TN14 RESPONSE TO FURTHER LHA COMMENT - EMPLOYMENT

VERSION	DATE	PROJECT NUMBER AND NAME	CREATED BY	REVIEWED BY
5.0	06.02.2025	23161 – Buntingford	JD	MG

3. LHA COMMENT AND RESPONSE

PROJECT REF: 23161	STATUS: N/A
DRAWING No: 030	REV: P1

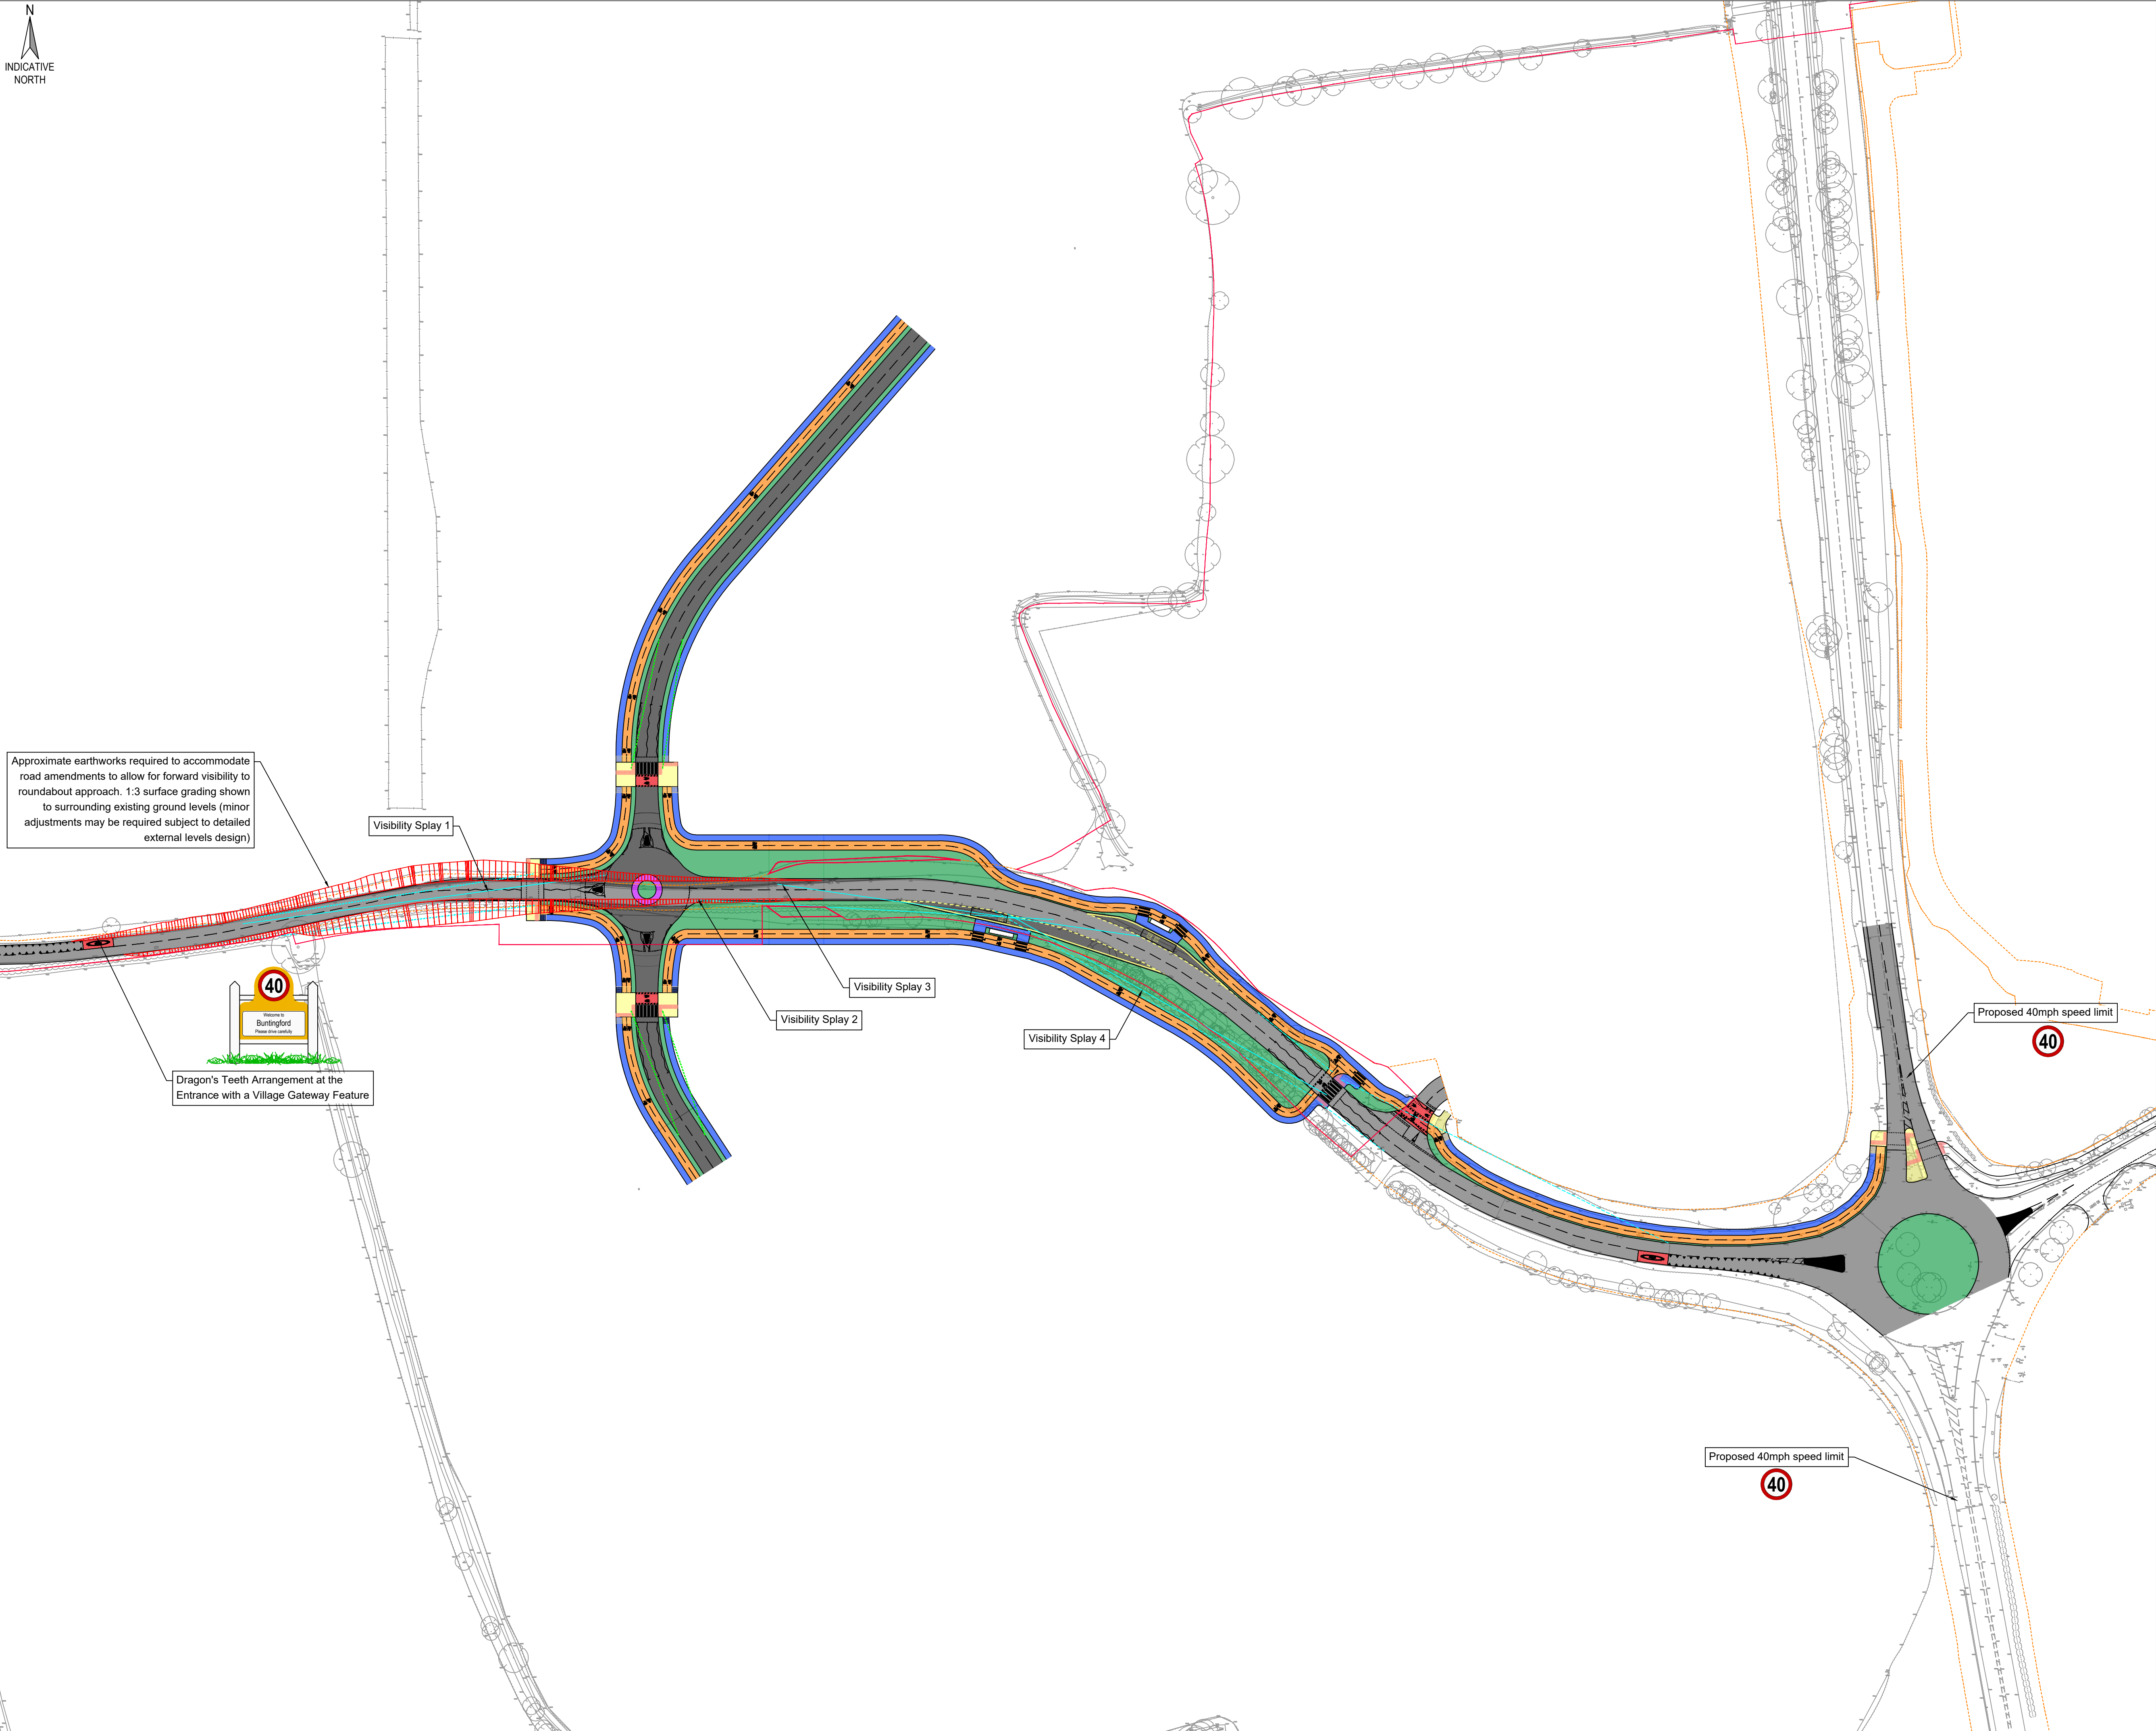
"Drawing 23161 030 Rev P1: Baldock Road Roundabout – southern access

- Deflection on approaches to the site roundabout are considered insufficient, particularly those on the Baldock Road approaches, and will not encourage reduced speeds. Deflection should be in line with CD116.
- The crossing of the A507 should be located closer to the proposed bus stops on Baldock Road to encourage use of this mode.
- Given the higher speed nature of the A10 the crossing must be located at least 20m north of roundabout as required by DMRB CD116 and not the circa 12m currently shown.
- The location of the proposed southbound 60mph to 40mph speed limit change on the Northern A10 approach is too close to the Toucan crossing for vehicles to have slowed sufficiently by the time they reach it. Further, HCC RSA team comments are needed.

- 3.1.19. It is noted that these responses review the original drawing as presented in Appendix D of the RSA brief (**Appendix C**). Since then, as set out in **Section 2**, the access strategy has been amended in consideration of specific comment made by the LHA in relation to the northern residential application proposals. Notwithstanding this a response to each comment made by the LHA on this access is provided below in any case and where relevant refers to the new proposed design.

- 3.1.20. The response to each bullet is set out in order as follows:
- Bullet 1 – Following discussions and agreement in relation to the residential proposals, as discussed in **Section 2**, the segregation of the main cycleway / footway has now been removed. On this basis it is considered the crossing should also remain shared as shown in the plans within **Appendix E** and **F** to remain consistent.

PROJECT REF:
23161
DRAWING No:
003

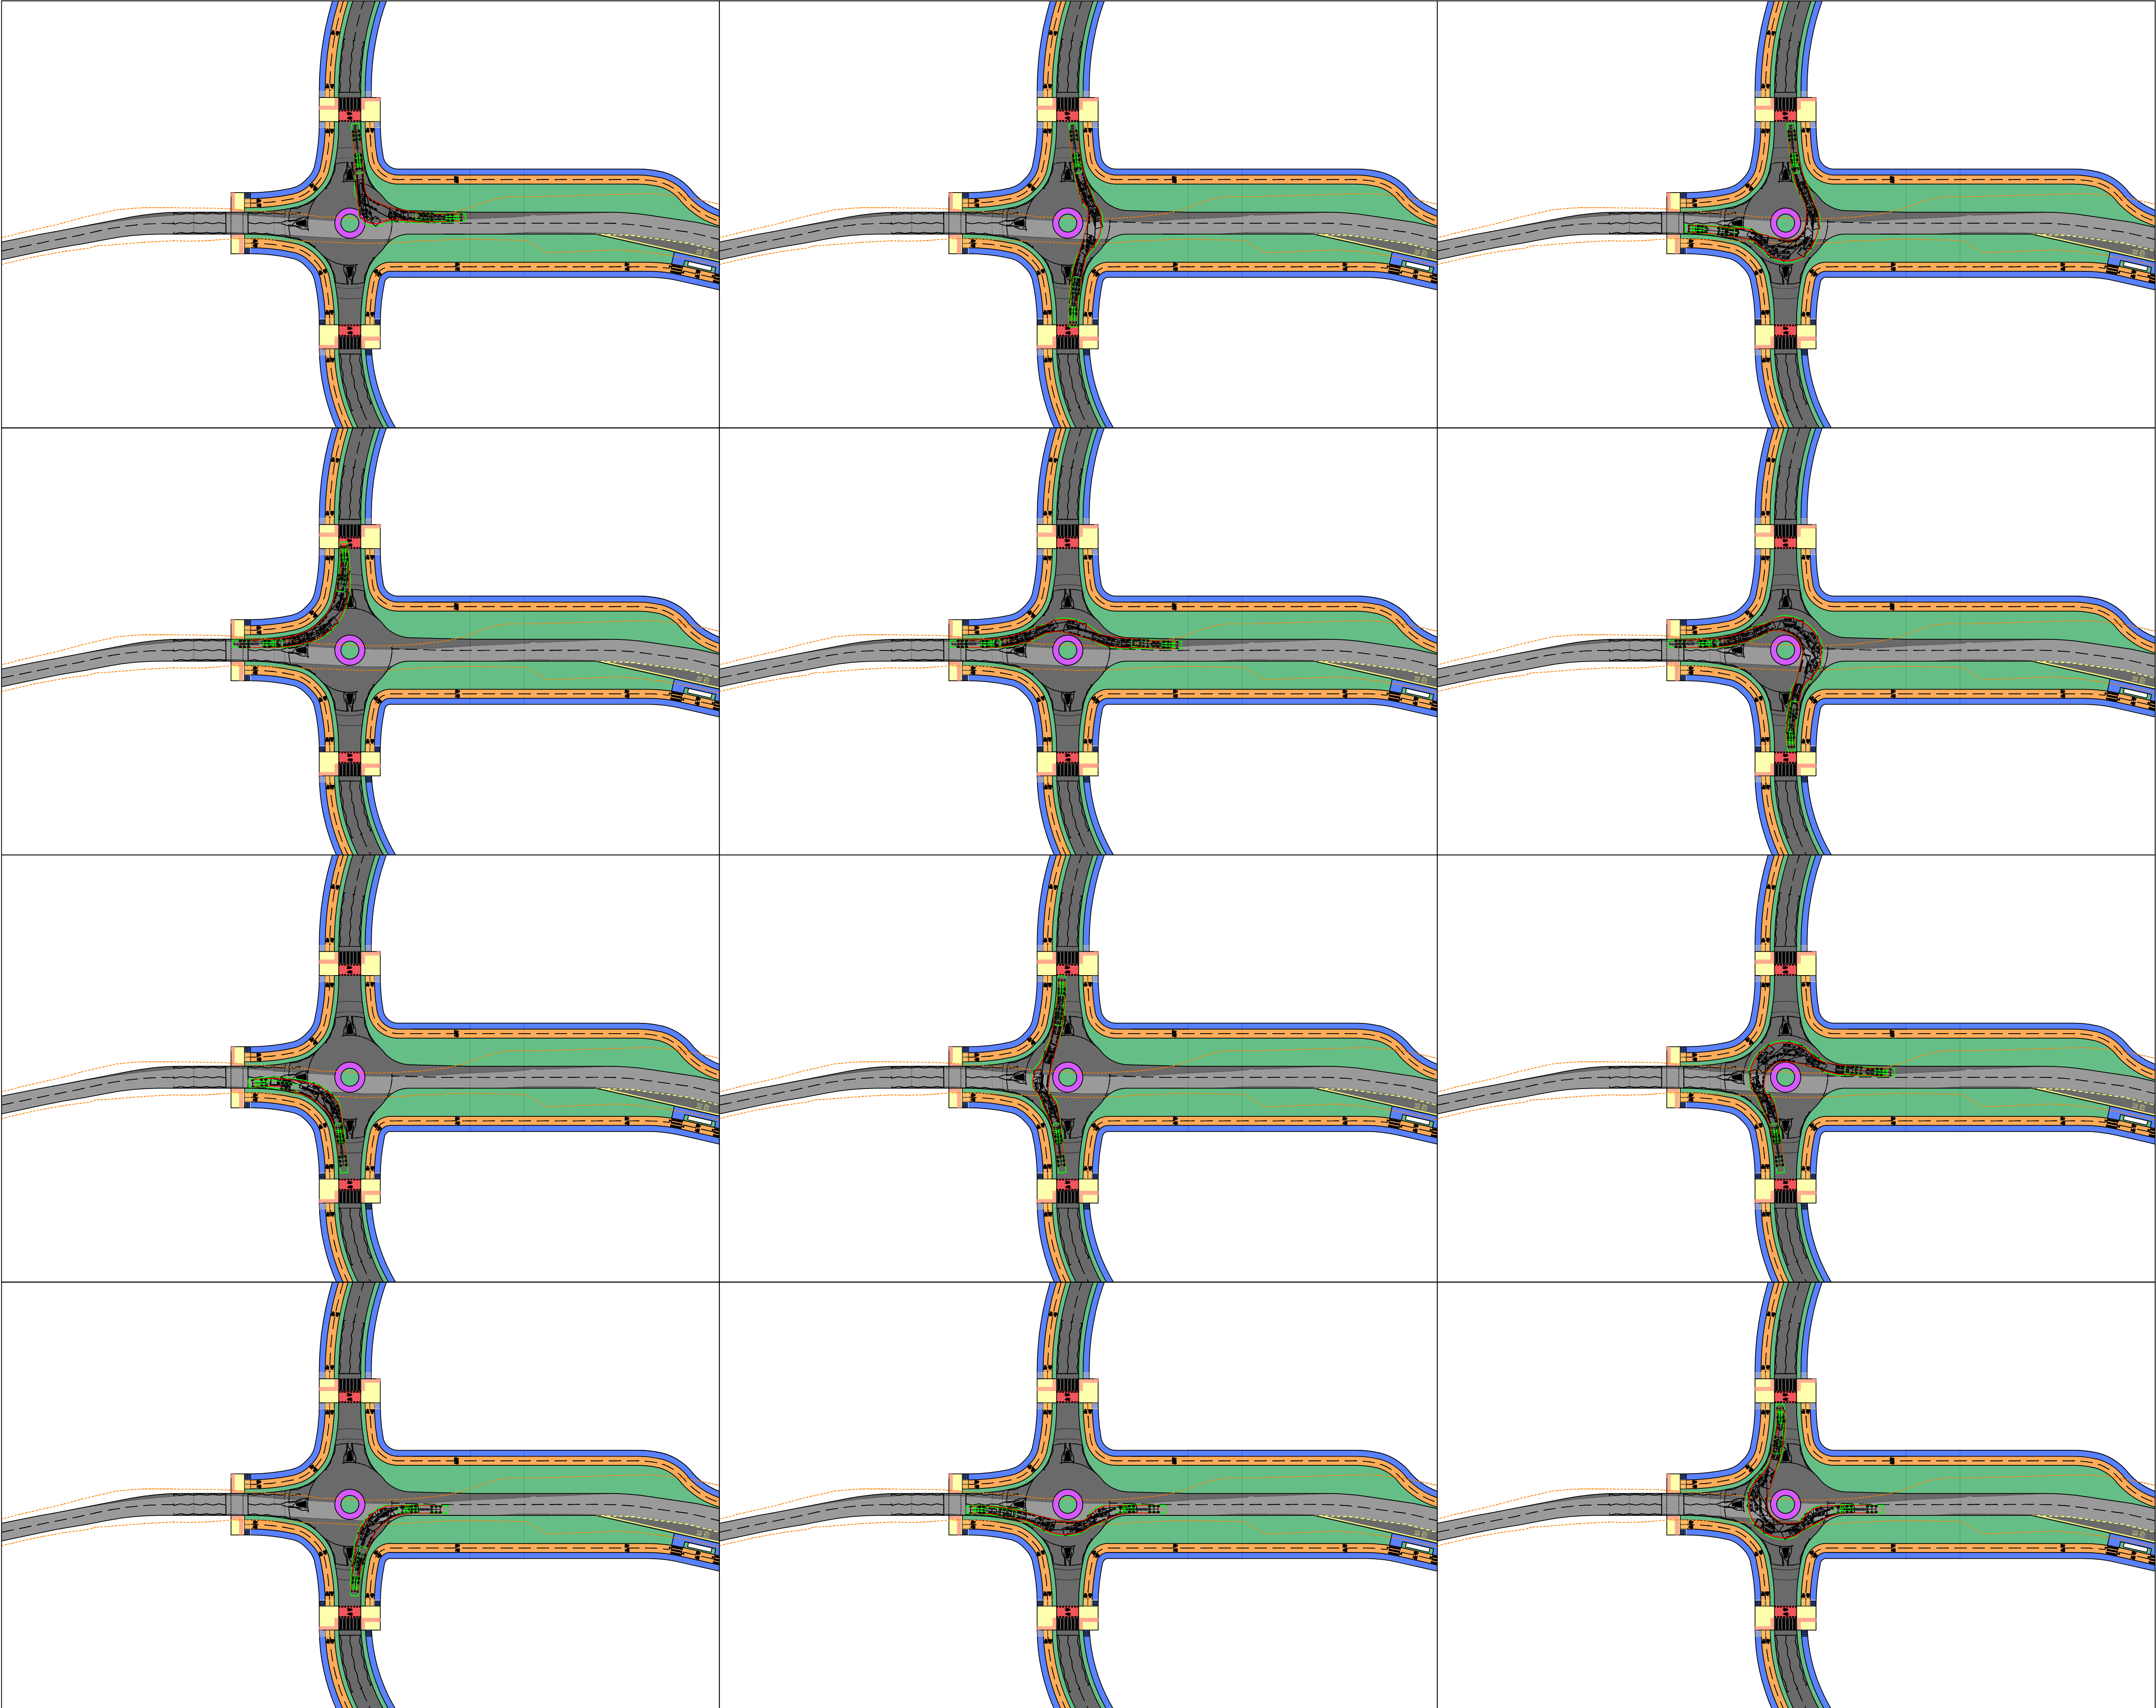
- The transition between the shared use footway and the residential road (Deacon Place cul-de-sac) carriageway should be considered more thoroughly than appears on the drawing.
- Have Crossings been Identified as complying with LTN 1/20 Table 10-2.
- The width of the road narrowing located just to the east of The Pyghtle must not be in the critical 3.2-3.9m range that is dangerous to cyclists.
- The continuous footway proposed across The Folly should be designed in accordance with HCC Standard drawings HST-1100-50 and 51.
- It is likely that cyclists will not use the proposed cycle stands located circa 100m from the village centre and instead continue to it. The interaction of cyclists and traffic needs to be considered and appropriate speed controls introduced.

- 3.1.22. The response to each bullet is set out in order as follows:
- Bullet 1 – It is noted that, as shown in the extract in **Figure 3.1** below, there is significant available highway boundary on the landscape area to the north. Thus, there is space to introduce the bus shelter in this location to the back of the shared footway / cycleway and the exact detail can be provided at detailed design as part of S278 drawings issued post consent.

- Bullet 2 – Proposed amendments to the design of the Greenway junction, and other bell mouth junctions on route to central Buntingford, to narrow the road to reduce active travel crossing distance have already been included for in the latest proposals for Baldock Road to the east of the A10. These revisions were agreed in discussions with the LHA in relation to the Residential proposals and are included in the drawing as **Appendix H** of this TN.

- Bullet 4 – LTN1/20 Table 10-2 confirms that at the proposed parallel type crossings, east of Greenways and west of Bowling Green Lane some users may have more difficulty crossing for higher flow roads. However, it is noted that the proposed raised table features should provide further comfort for users in this regard through the lowering of traffic speeds.
